BLOCK 37

DESIGN REVIEW

CASE # LU 14-117884 DZM

DESIGN REVIEW AUG. 21, 2014

GROUND FLOOR PLAN

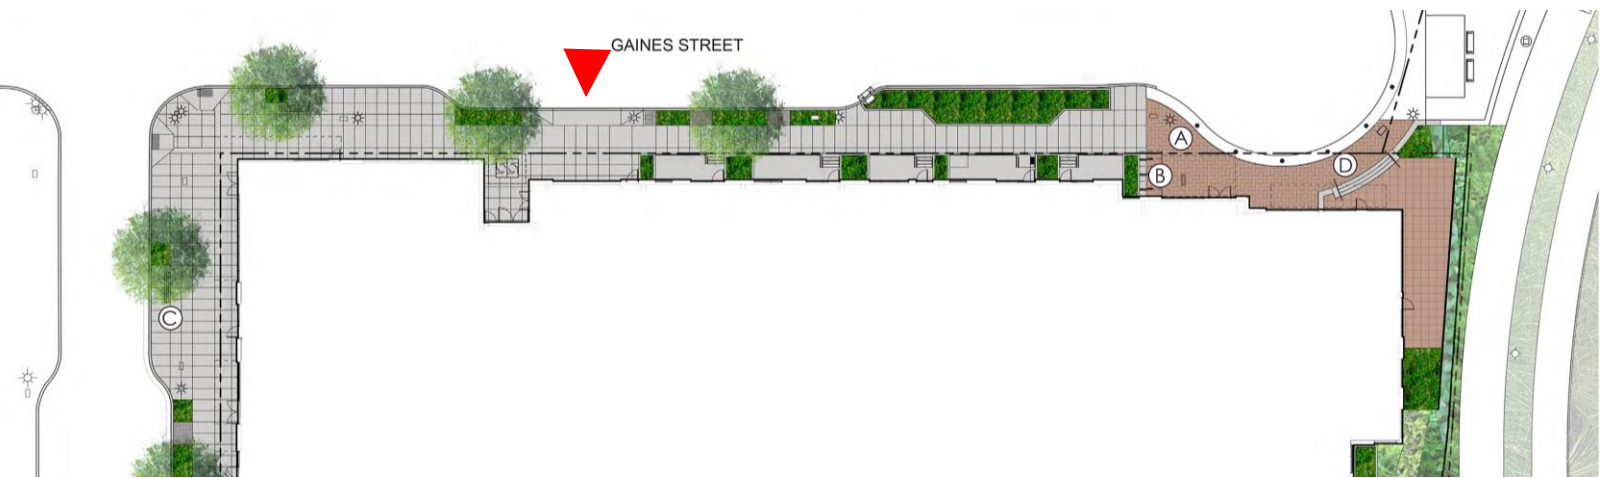
1. REVISE GARAGE ENTRY LOCATION
2. ADD BALCONIES TO THE NORTH ELEVATION. INSET BALCONIES PREFERRED
3. INCREASE SIZE OF RETAIL PATIO ALONG GREENWAY
4. IMPROVE MATERIAL COHERENCY AT THE NORTHEAST CORNER
5. ADD BALCONIES TO THE SOUTH ELEVATION. INSET BALCONIES PREFERRED
6. EXPLORE POTENTIAL FOR ADDITIONAL BALCONIES ALONG WEST FACADE.
7. PROVIDE ADDITIONAL DETAILS FOR LOUVERS, PARKING ENTRY AND BOLLARDS ON LANE ST.

GARAGE ENTRY

PARKING ENTRY
ADDITIONAL RETAIL SF

GROUND FLOOR PLAN

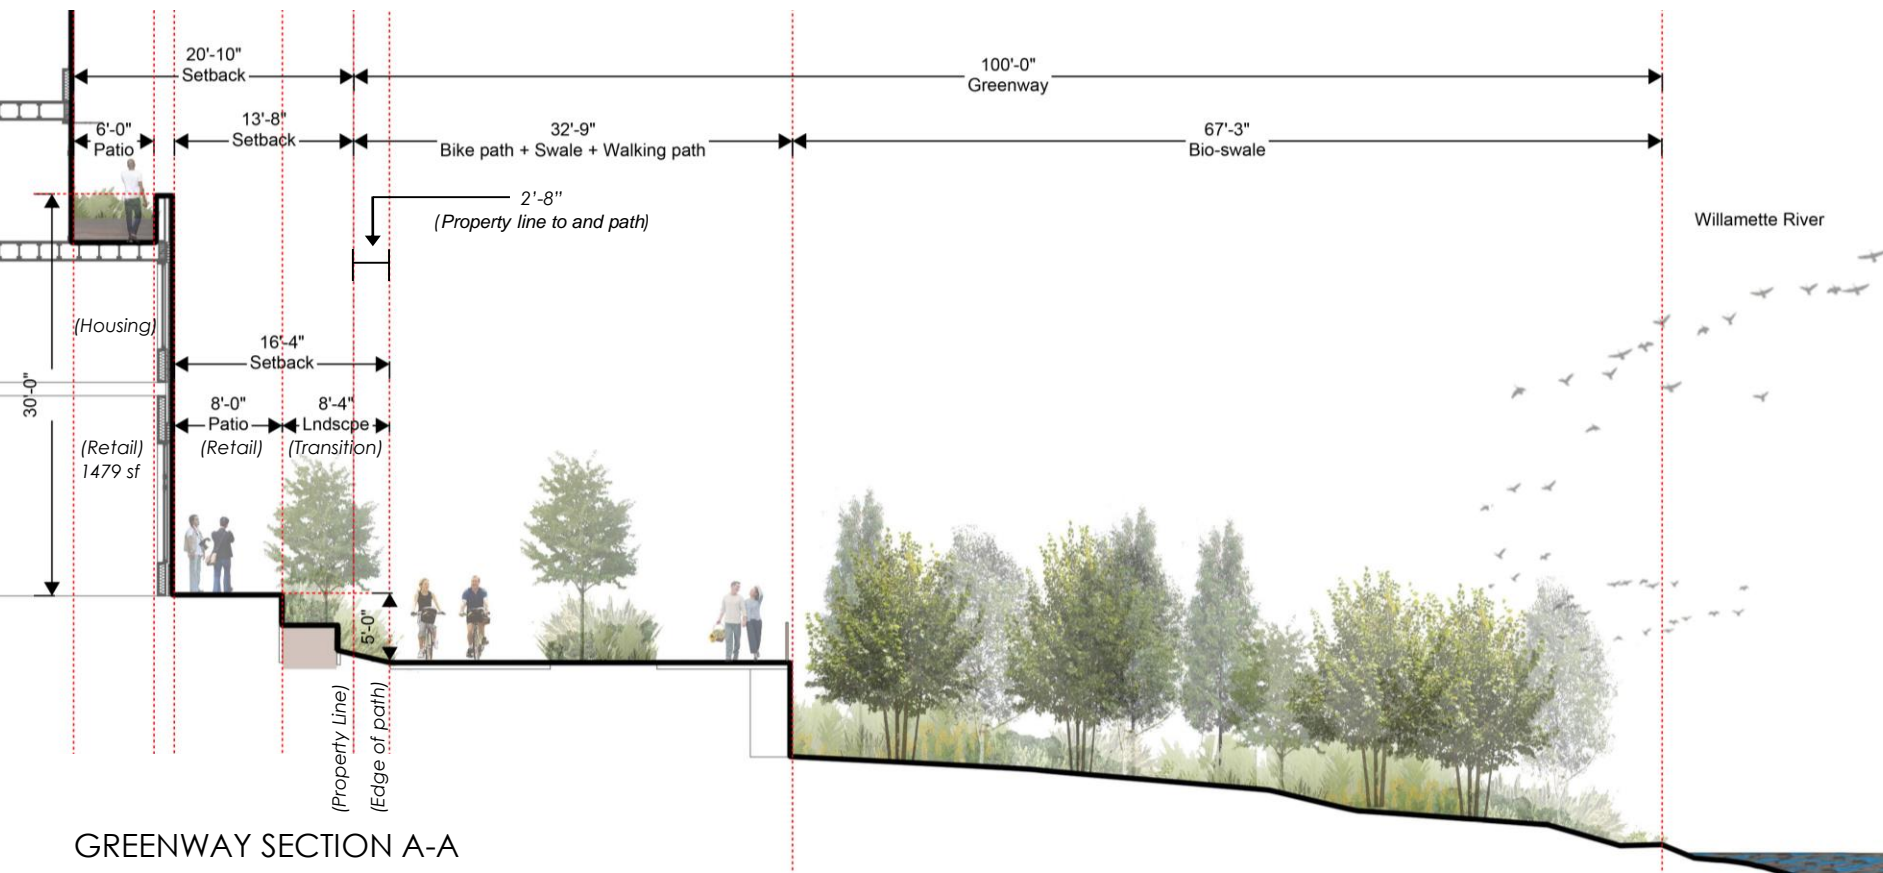
GREENWAY PATIO

RETAIL PATIO
RETAIL 1,500 SF

NORTH ELEVATION (Gaines St.)

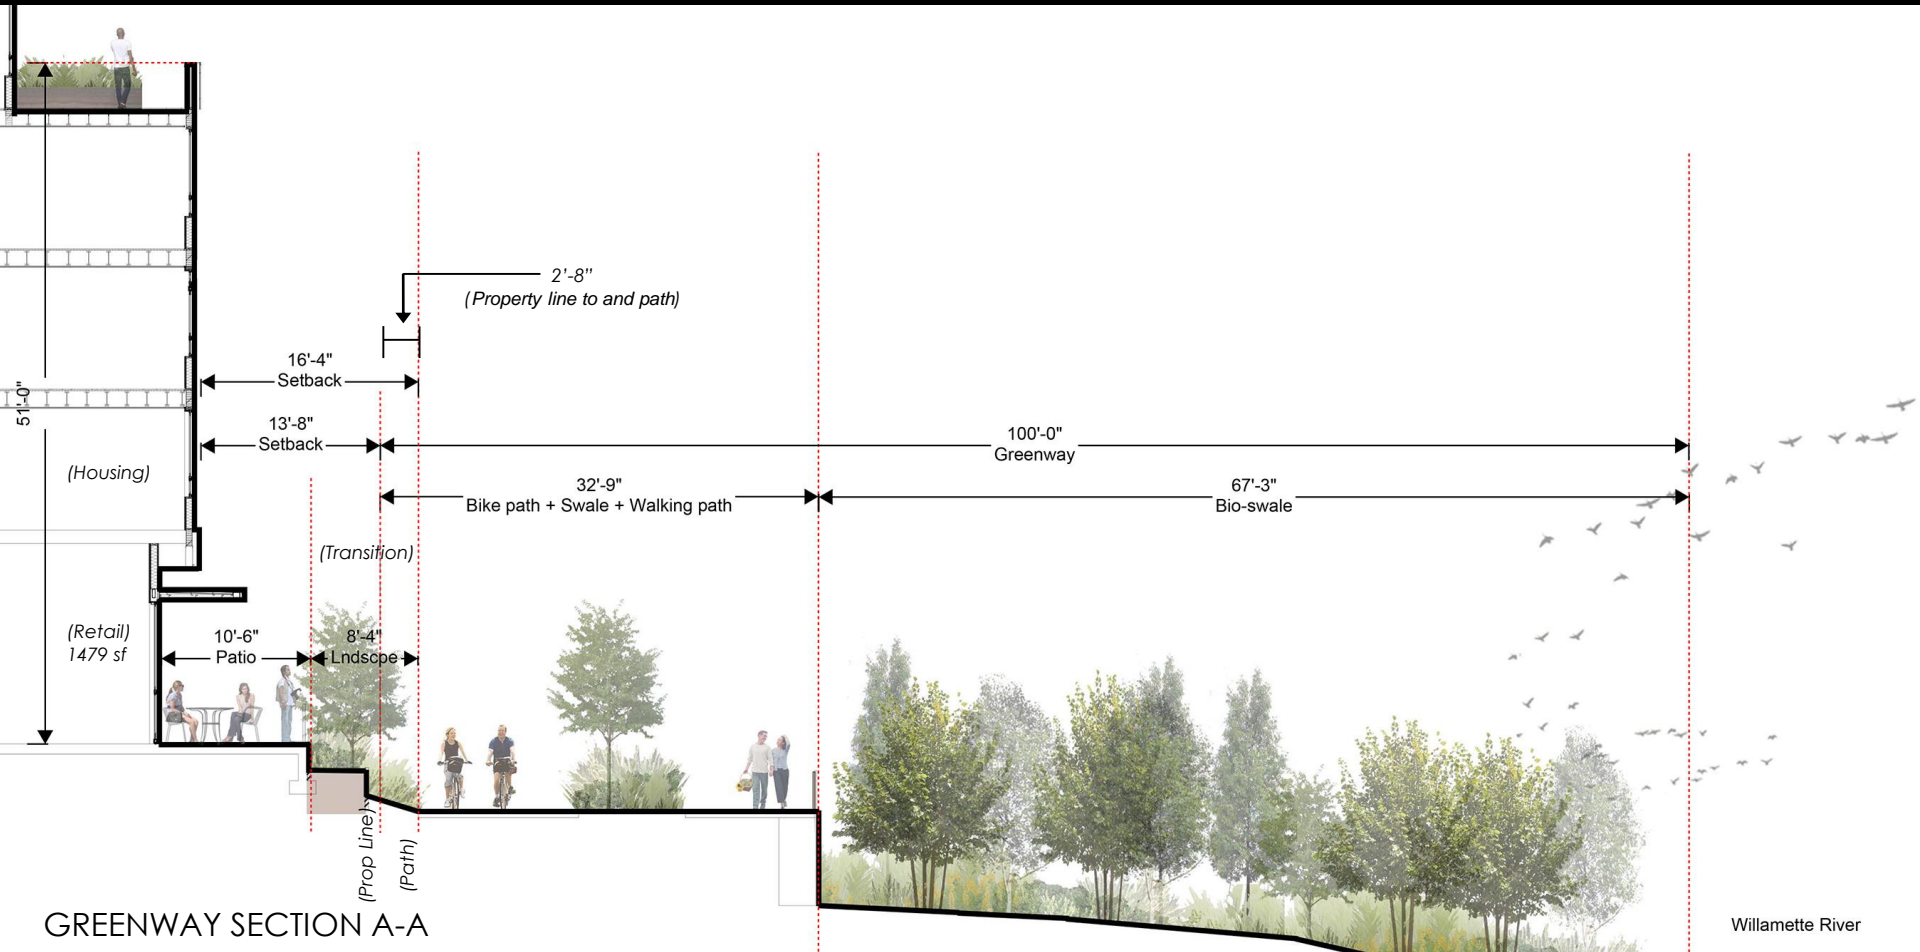
BALCONIES

(NORTH FAÇADE)

GBD RESPONSE

EAST ELEVATION (Greenway)

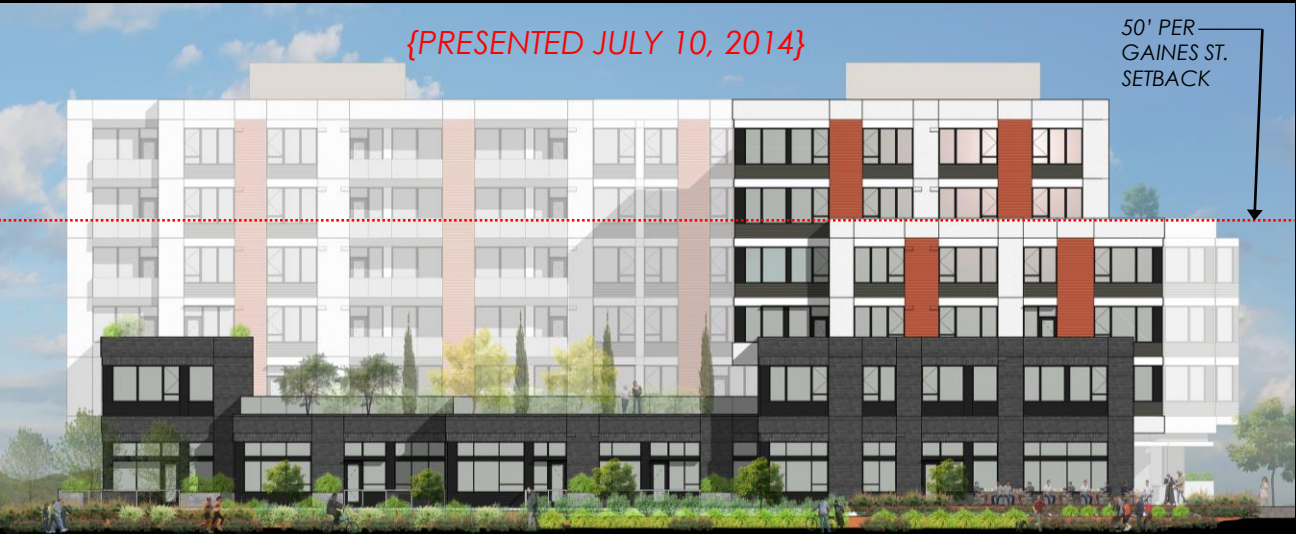
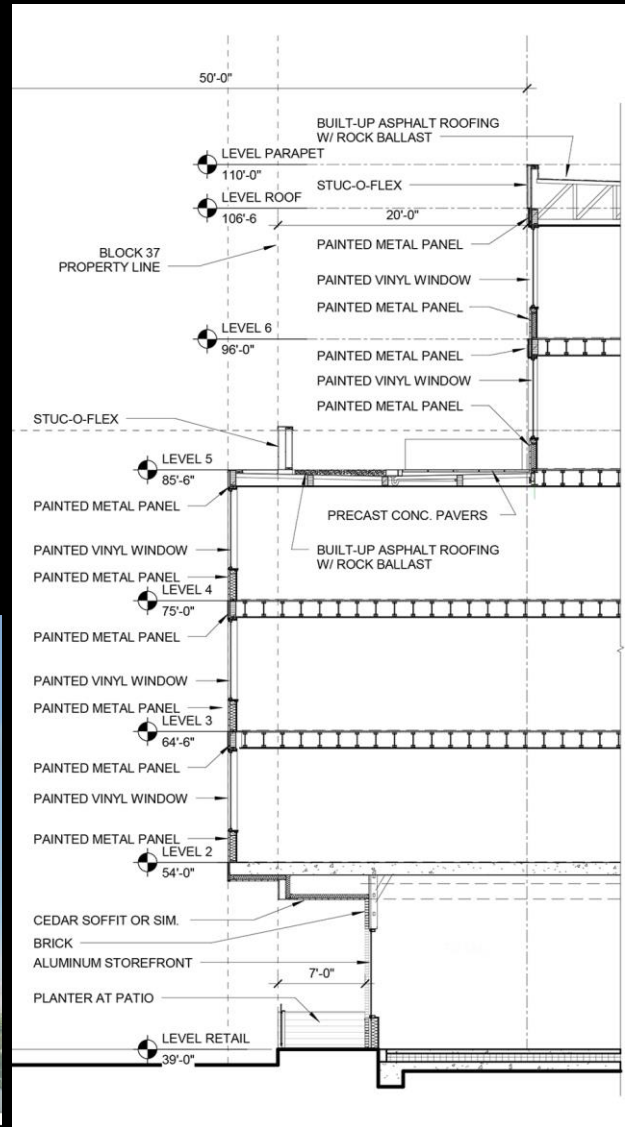
COHERENCY

(NORTHEAST CORNER)

GBD RESPONSE

SOUTH ELEVATION (*Lane St.*)

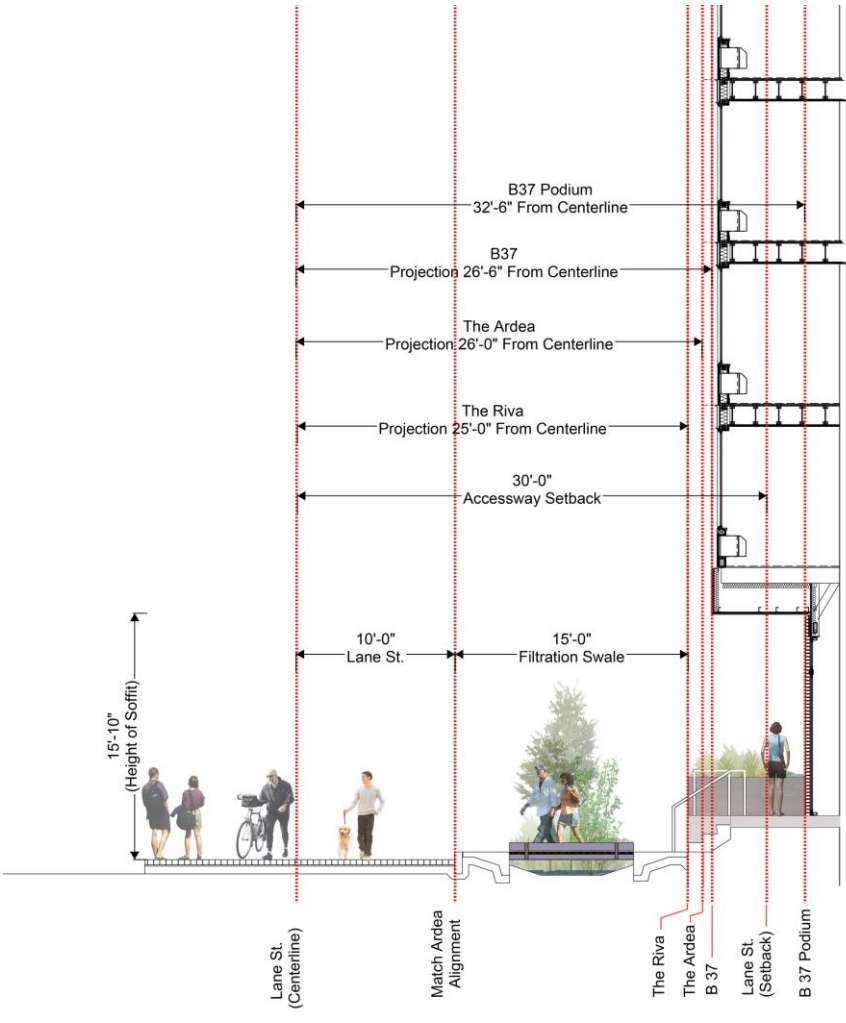
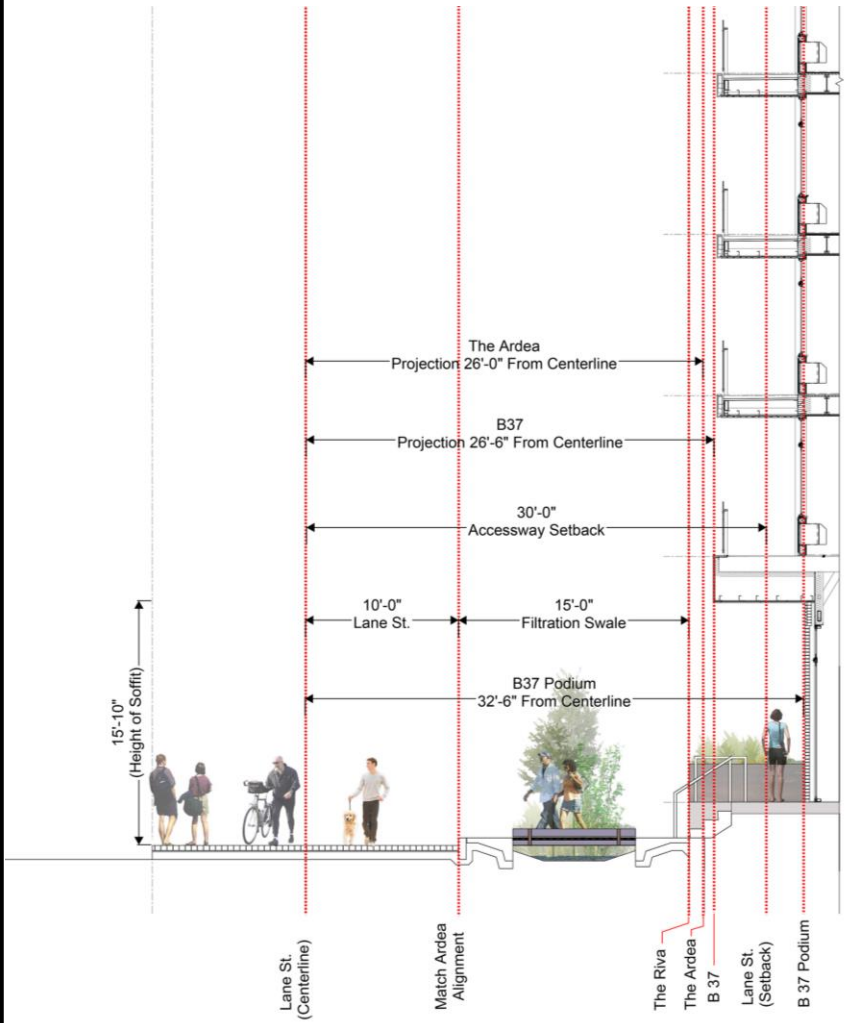
BALCONIES

(SOUTH FAÇADE)

WEST ELEVATION (SW River Parkway)

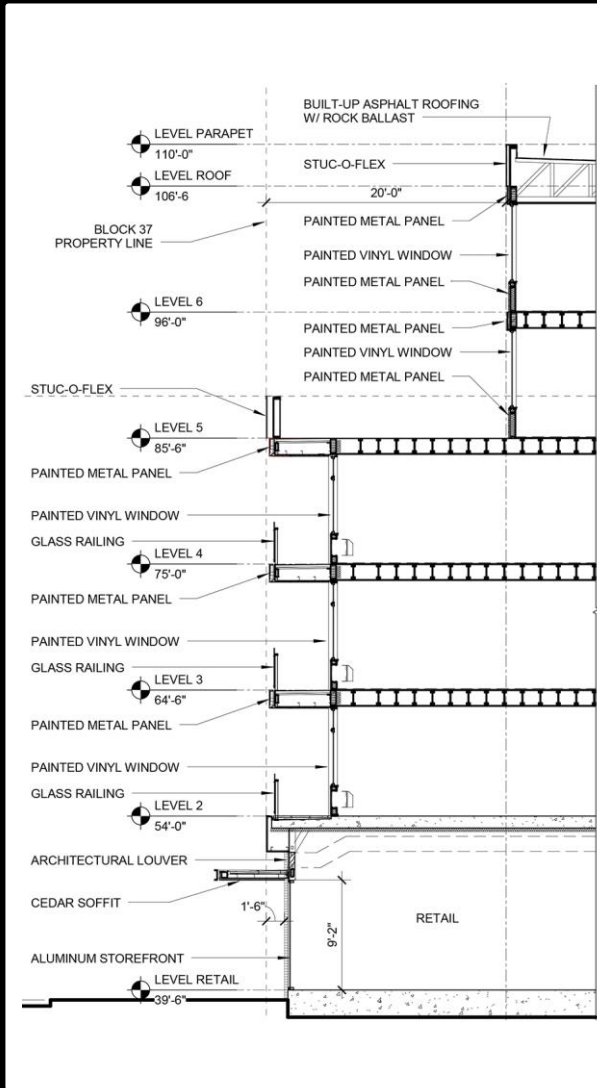
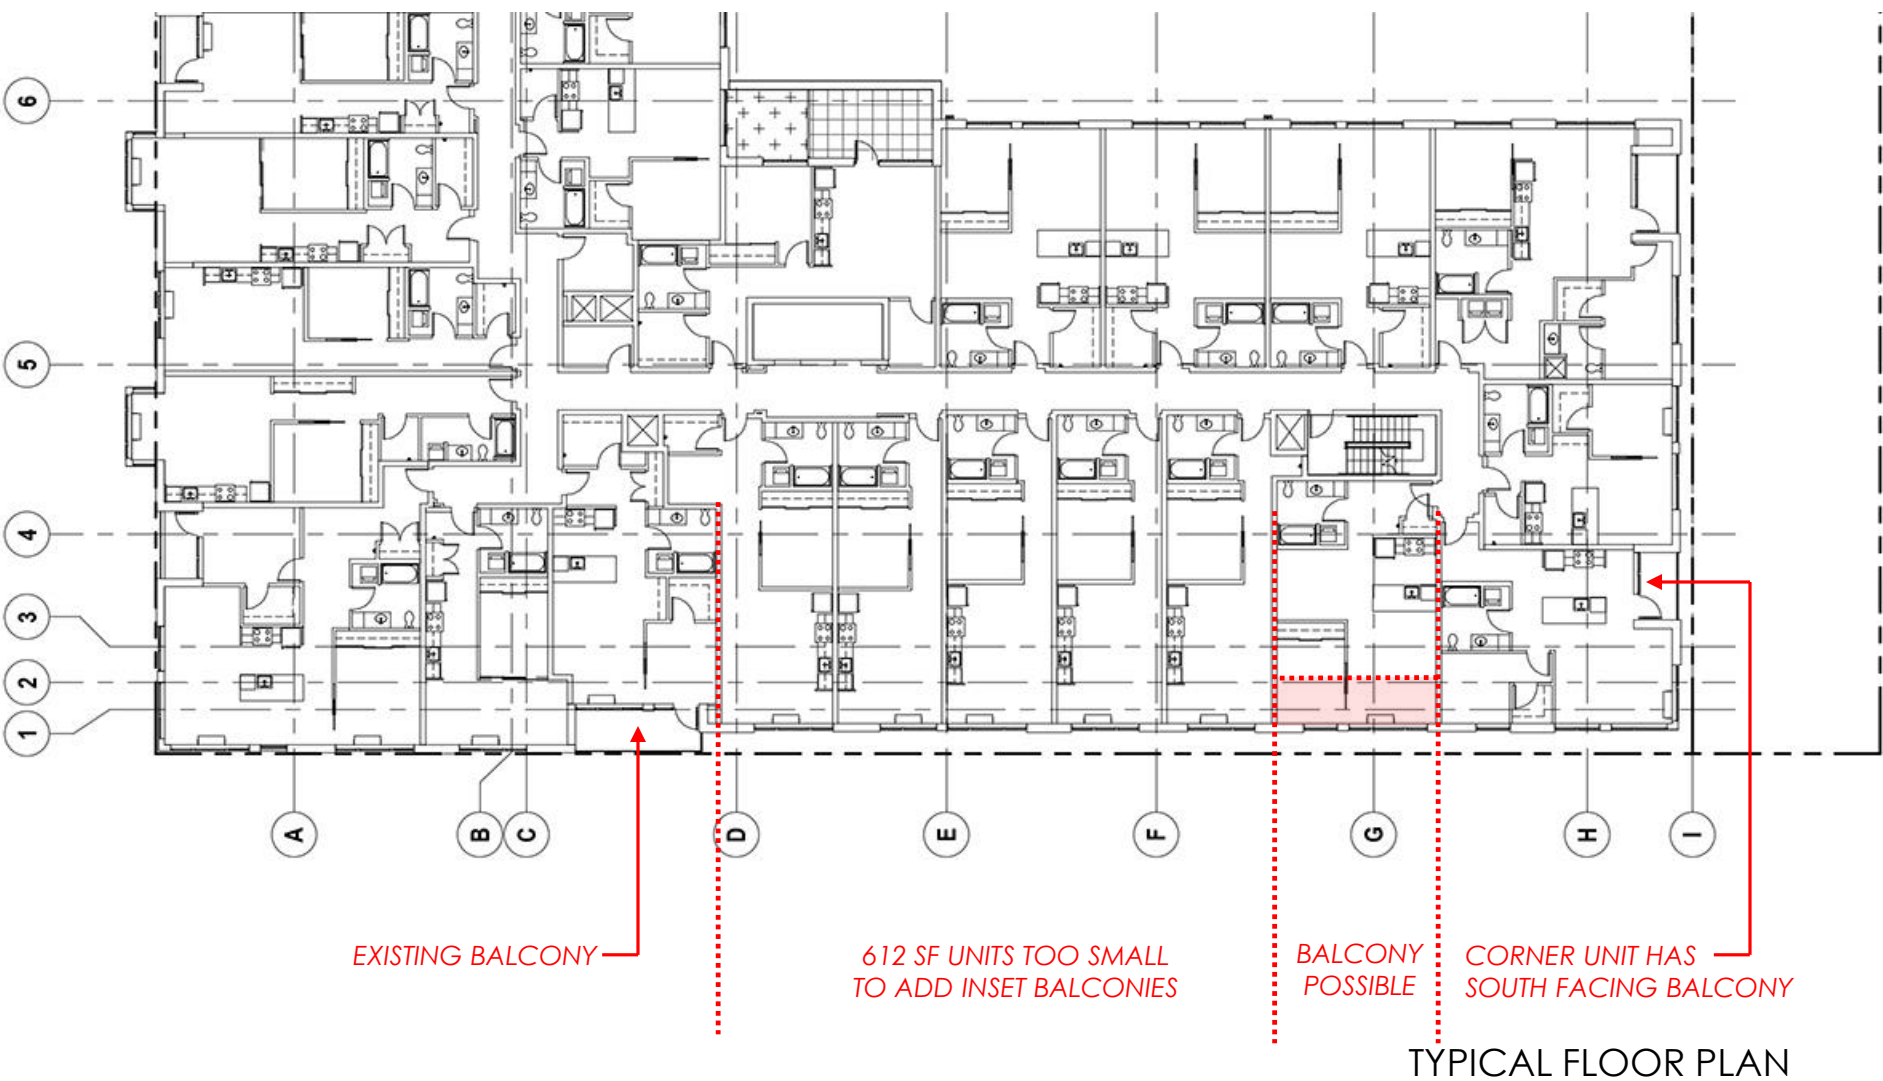
BALCONIES

(WEST FAÇADE)

GBD RESPONSE

SKETCH – WEST FAÇADE W/ ADDED BALCONY

4 VERTICAL LIFT GARAGE DOOR SECTION @ PARKING ENTRANCE
1/2" = 1'-0"

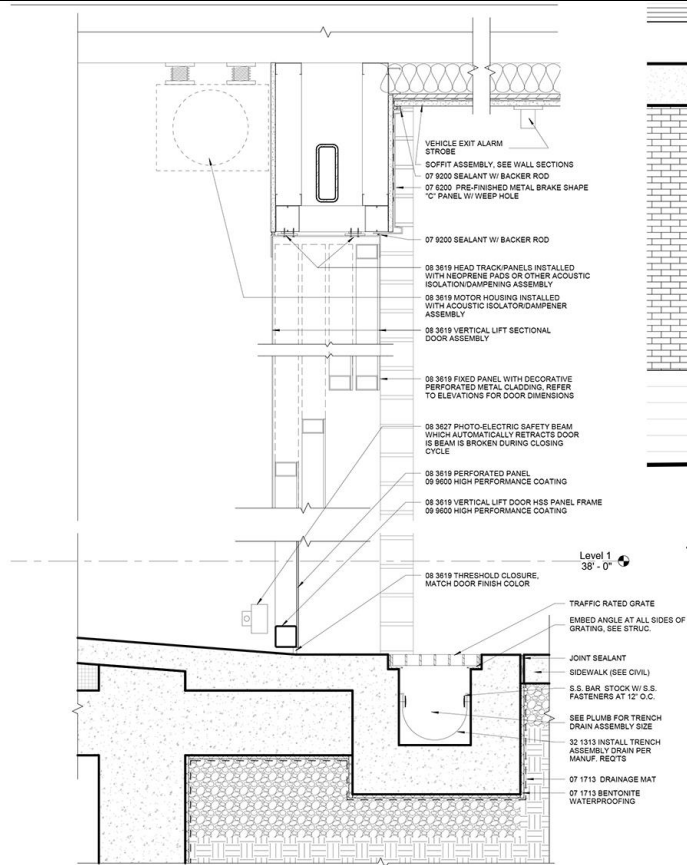
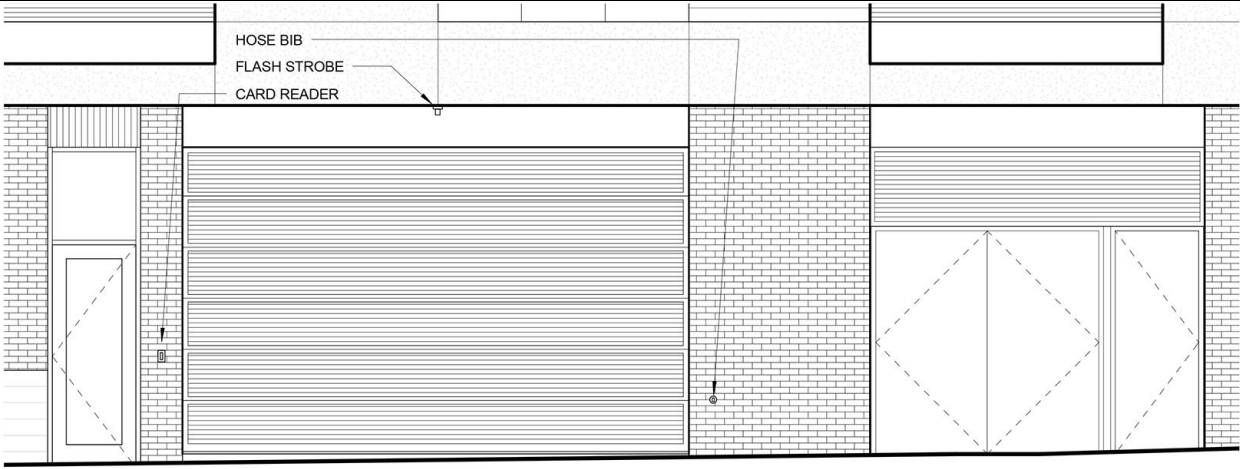
DETAILS
